## TAS3202 Data Sheet Errata

This errata document describes corrections to the TAS3202 data sheet, literature number [SLES197](#).

### 1 Erratum: I<sup>2</sup>C Data Setup Time Violation

**Figure 1. Problem Description: Timing Diagram**

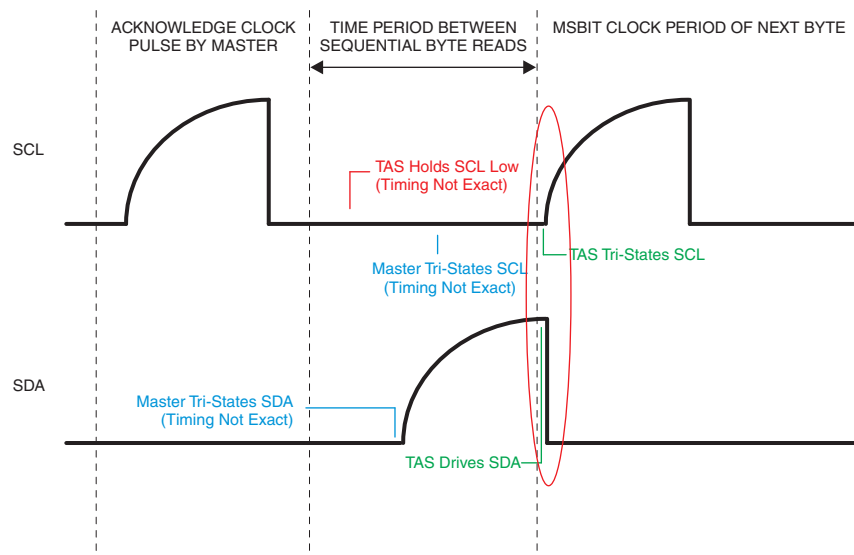
The TAS3202 slave I<sup>2</sup>C interface does not meet the minimum set up time for the Data ( $t_{SU,DAT}$ ) of the I<sup>2</sup>C Bus Specification in between payload bytes while transmitting to the I<sup>2</sup>C Bus master.

Figure 1 shows a view of the time window between any two sequential payload bytes of an I<sup>2</sup>C Read Transaction. The time window where the violation occurs is highlighted in red. Figure 2 shows the same violation in a much smaller time window

The rising edge of the Serial Clock (SCL) overlaps with the falling edge of the Serial Data (SDA). This overlap may cause conflicts with other integrated circuits on the same I<sup>2</sup>C bus, resulting in a hung bus.

The I<sup>2</sup>C bus Master may insert an artificial clock stretch (hold SCL at logic 0) between every sequential set of the nine SCL clock pulses (for each byte) for a fixed time period of no less than  $\frac{1}{2f_{SCL}} + 250$  ns immediately after the falling edge of the 'Acknowledge' clock pulse.

This clock stretch by the master results in added time for the SDA to be driven low by the TAS3202 before the I<sup>2</sup>C bus sees the rising edge of the serial clock to meet the minimum  $t_{SU,DAT}$  specification
